Detailed Element Need for Change

4.1 Need for Change

Cores and Services

Cores and Services Changes

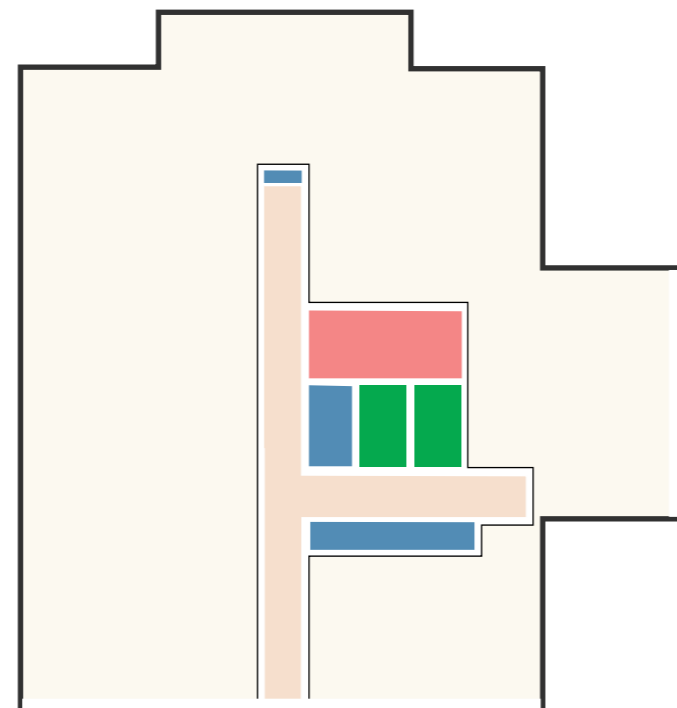
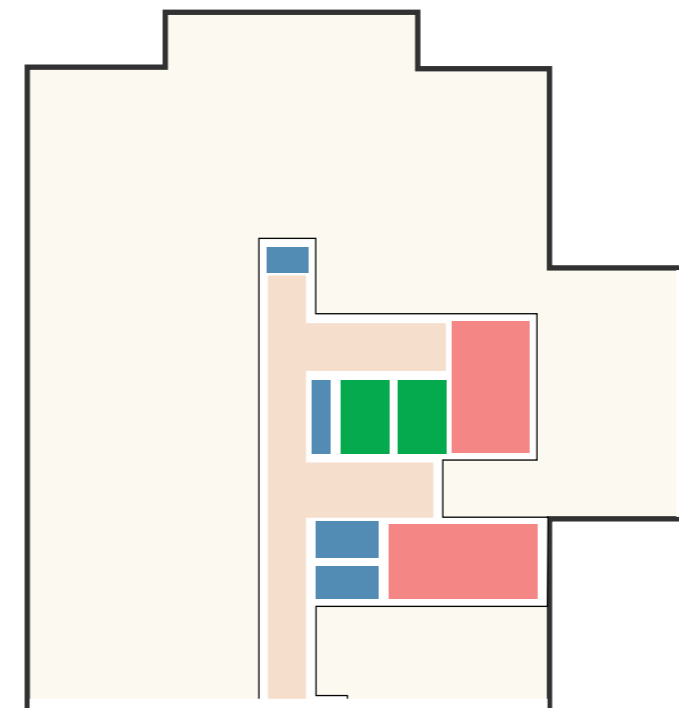
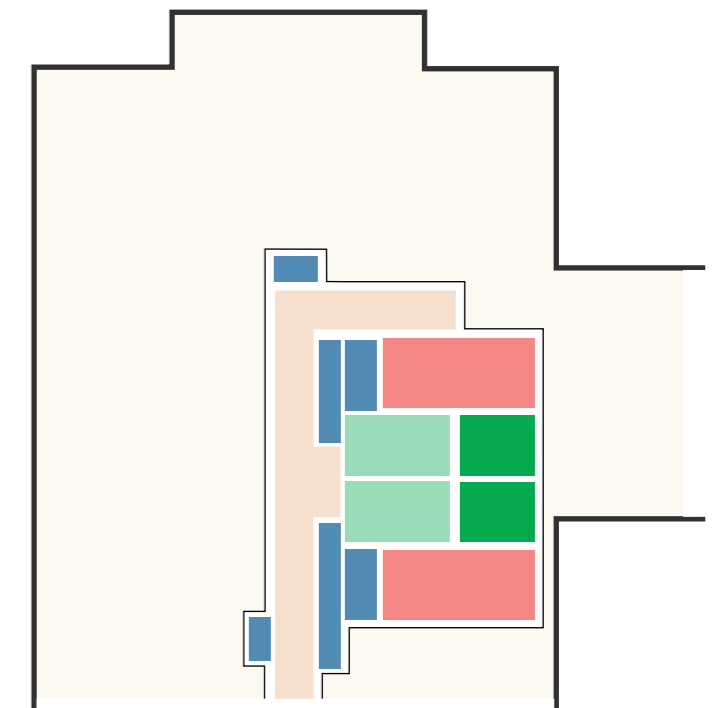
The main impact of these regulatory changes to the approved detailed design of the Detailed Element was to steadily increase the size of the cores within each building.

In February 2023, an addendum to the application was submitted to incorporate second means of escape to each building, based on fire safety guidance which was being consulted on at the time. As a result, the amount of core and services increased compared to the original January 2022 submission. It was the February 2023 design which was granted planning permission. Subsequently the fire safety guidance was finalised and published, including the London Plan Fire Safety Guidance and Building Regulations Approved Document Part B (Fire Safety) Amendments. It was established that the design of the buildings as approved should be updated to meet the latest guidance.

At this stage, the Applicant commissioned the design team to revise the detailed element to meet the updated guidance. Again, the regulatory changes led to a further increase in the size of the cores. As the overall footprint of each building remains largely the same, this increase in cores over time has led to the steady decrease of internal space for the apartments. This began to significantly affect the overall number and unit mix of the apartments which could be accommodated compared to the approved design.

49 % Increased footprint of circulation and services (since Jan 2022 submission)

63 % Increased footprint of circulation and services (since Jan 2022 submission)
